**Reasoned Document for Comments Received on Draft Specification for Item
“Telecom Integrated Power Supply System for Station as per RDSO/SPN/TC/102-2013”**

4.2 Requirement of ASM Panel:

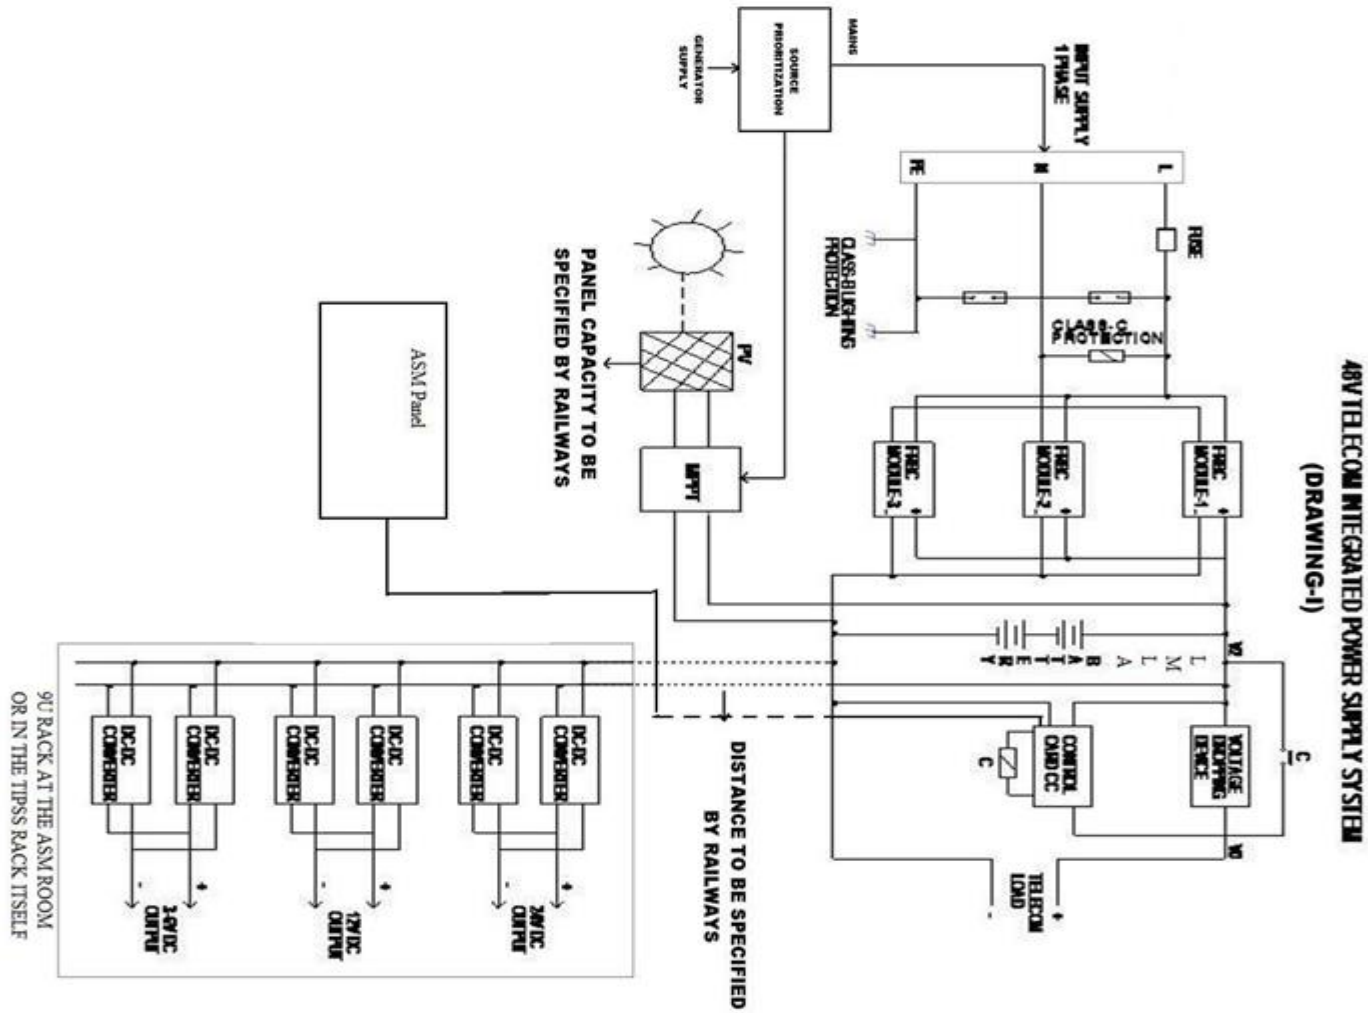
2.7	One panel consisting of status indications and critical alarms of TIPSS is to be provided in ASM's room. The monitoring panel shall be of wall mounting type. OEM shall supply 12 core, 1.5 sq.mm signaling cable as per IRS:S 63/2007 for connecting TIPSS to Status Monitoring Panel in Station Master's room (distance to be given by Railways at the time of indenting).	M/s Statcon	Pl add this in the “ Information required by purchaser”	Agreed	2.7	Clause 11.0 has been modified accordingly
		M/s Amara Raja	Numbers of indication LED's and details are not available in the specification to calculate no.of cables (cores) required between TIPSS system and monitoring panel. 12 cores may not be required if no.of indications are less.	New Clause giving the detail of indication added.	4.2	Description as on page 23 of this document.

RDSO Specification		Comments Received from		RDSO's View	Amended Clause	
Clause no					Clause no	
	4.No. of DC-DC Converter, voltage and rating. (1 Amp/5 Amp)					Wooden/FRP. 3.Solar (MPTT Charger)(optional) required /Not required. 4.No. of DC-DC Converter, voltage and rating. (1 Amp/5 Amp) 5. Distance of ASM Room from location of TIPSS. (In meters) 6. Distance of Battery Bank from TIPSS. (In meters)
New Cl		M/s Amara Raja	<p>Details of LED indications required in Status Monitoring panel may be included in Specification to have better clarity.</p> <p>We recommend these indications.</p> <ol style="list-style-type: none"> 1. FRFC/FRBC's Fault 2. DCDC Converters Fault 3. Solar Modules Fault(optional) 	Agreed.	4.2	New clause introduced Description as on Page 22 of this document.

Status monitoring panel shall be installed in the room of ASM on duty. The panel shall have following LED indications and alarms with resetting switch:

Instruction	Condition	LED Ind.	Remark
A	Run Gen set	50% DOD	RED	Audio / visual alarm. Alarm can be acknowledged for audio cut off.
B	Emergency start generator	60% DOD	RED	-do-
C	System shut down	70% DOD	RED	All DC-DC converters to work. Audio alarm will continue till Generator is started.
D	Call S & T staff	Equipment fault	RED	Failure of any module or in case battery gets disconnected from circuit will give the alarm in panel. Alarm can be acknowledged for audio cut-off.
E	Stop Gen Set	FRBC change over to float mode	GREEN	Audio /Visual alarm

Audio alarm in case of A, B & C shall be of one type of tone and there shall be different tone for the case of D & E cases.

In A, B & C conditions, the visual LED indication will remain lit until fault is cleared or the DG set is started and battery is charged upto 110V i.e. 2V/cell as the case may be until reset push button is pressed. In case of D condition, if fault is not cleared, the LED will continue to glow, even if reset push button is pressed.
